ADDENDUM NO. 1

L100 DEMO AND PREP PLAN

PROJECT:
**WHITEMORE PARK
Phase 2
Arlington, MA**

L100

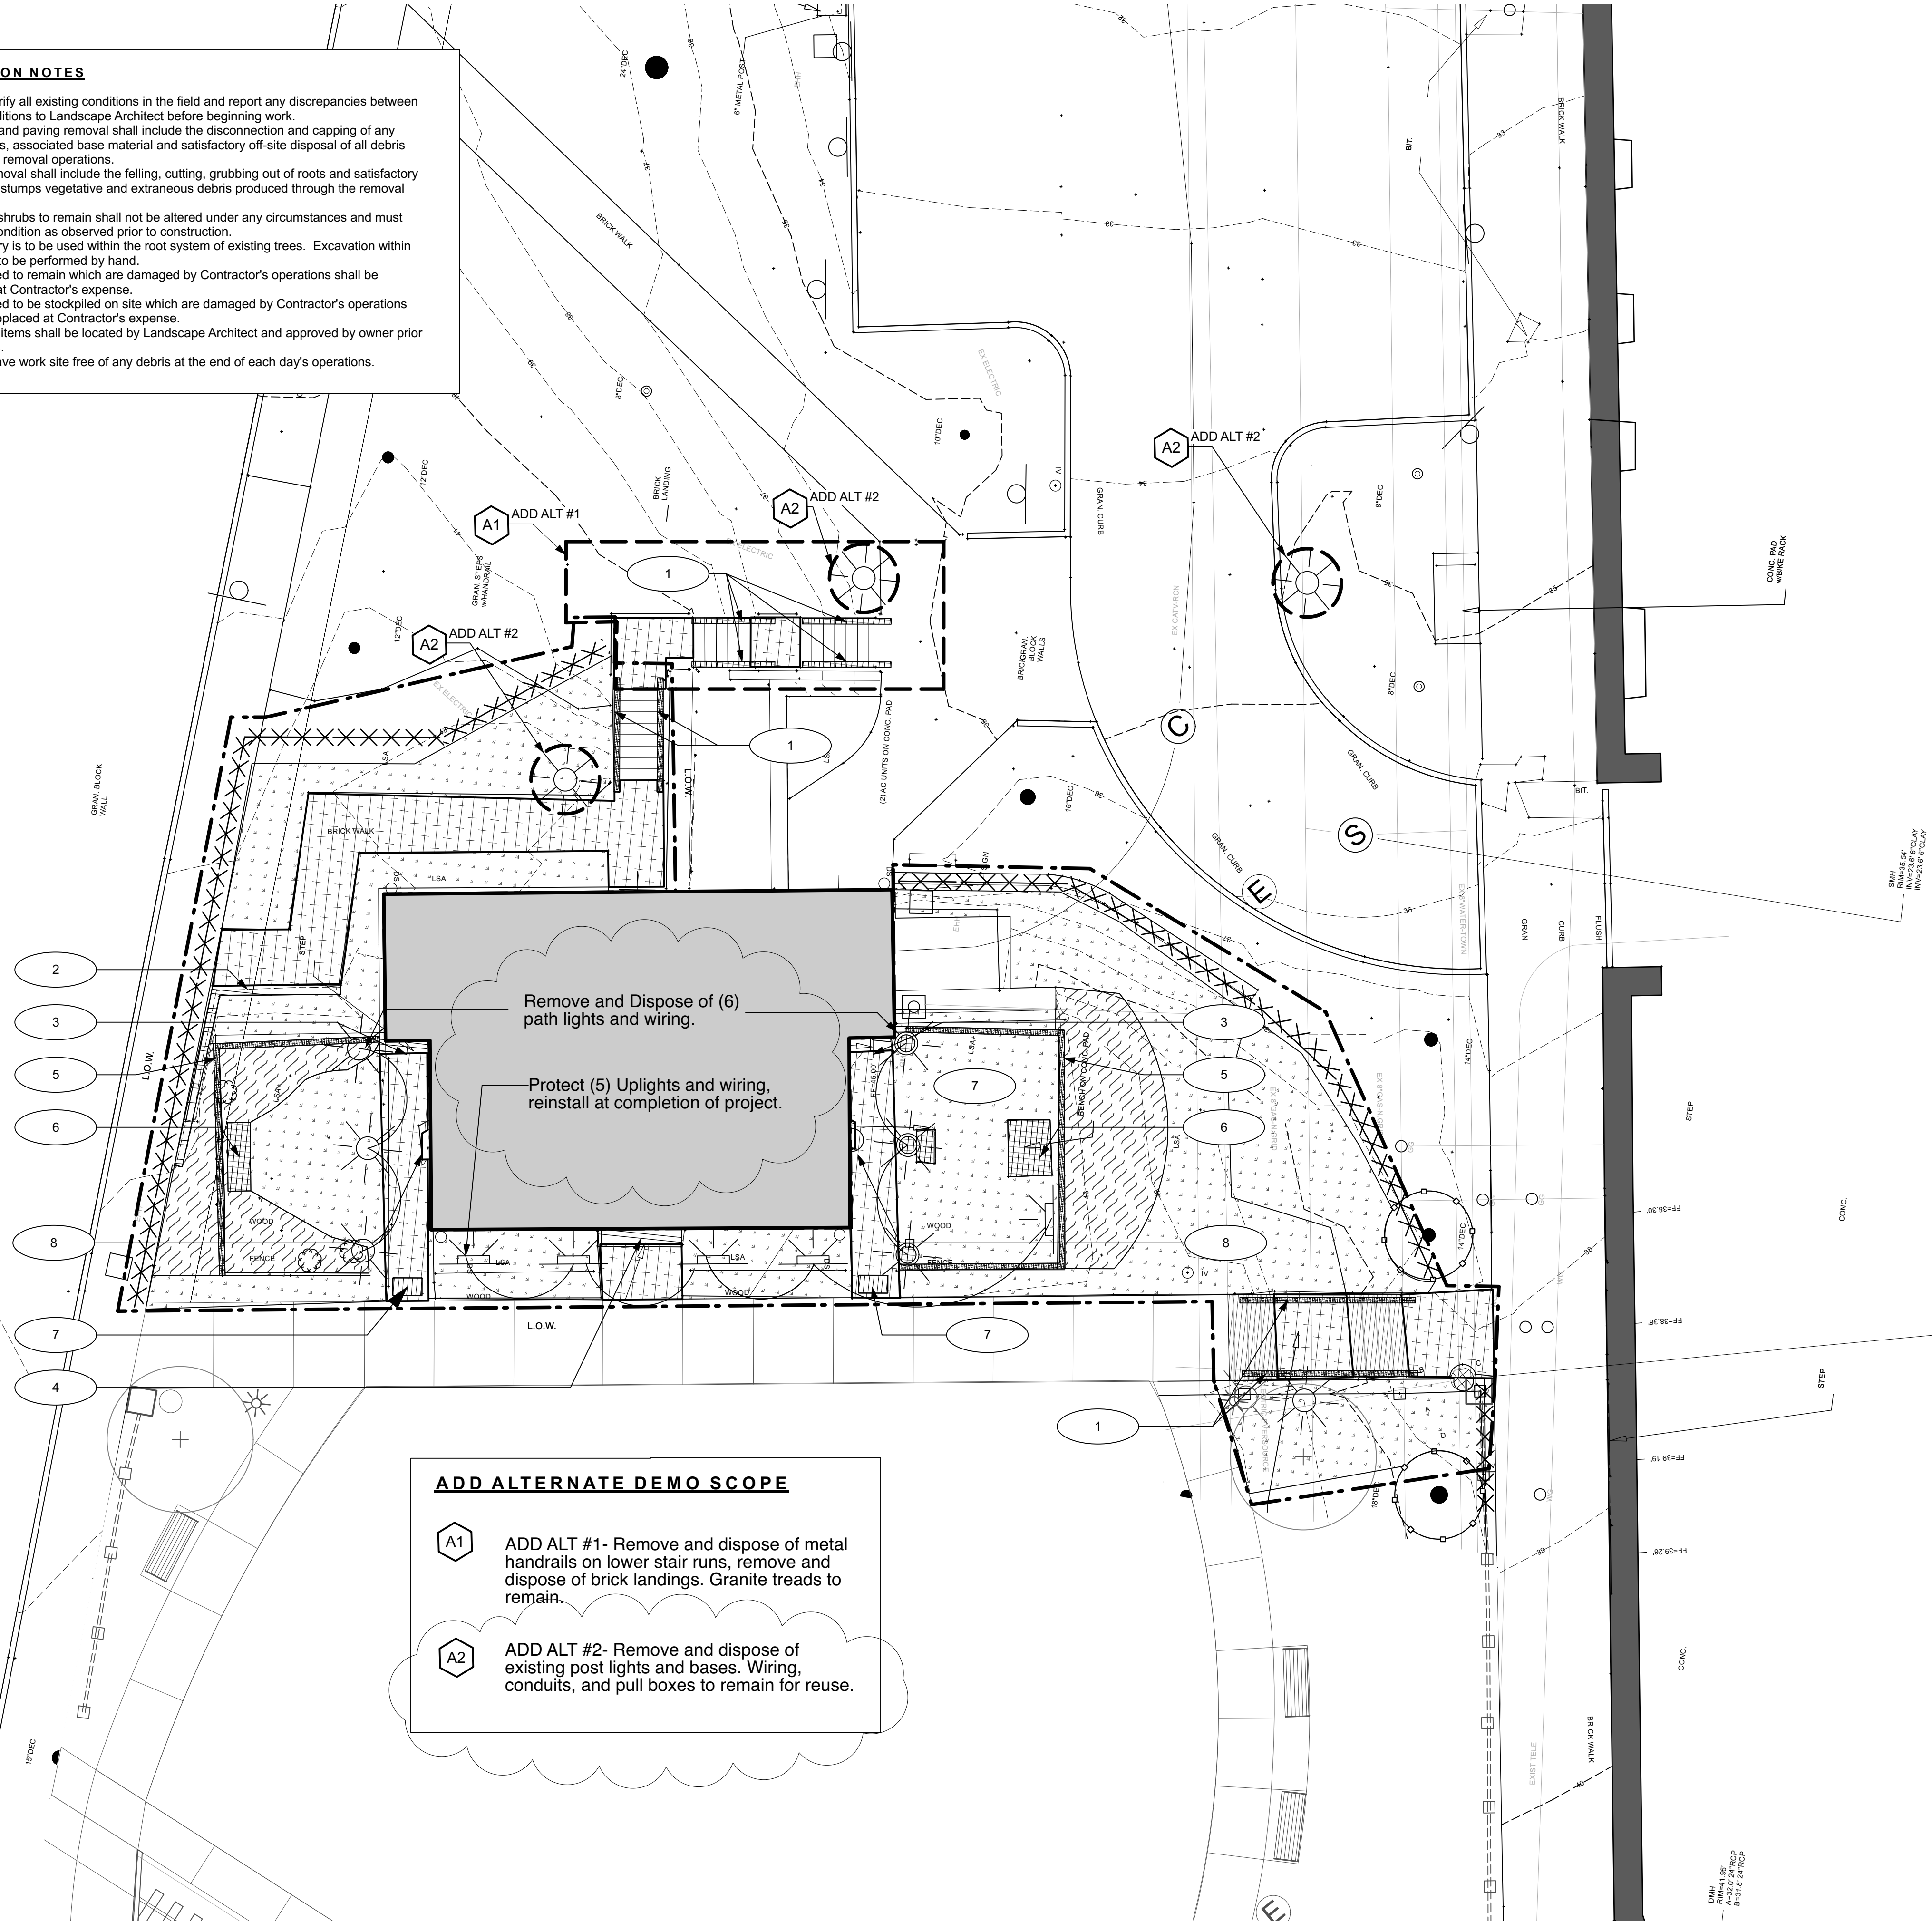
Please see attached revised L100, dated 02/21/22

8. Contractor to note changes bubbled as "Addendum 1". Changes included the removal of (6) path lights and wiring; and protection of (5) uprights and wiring for re-installation at the end of the project.
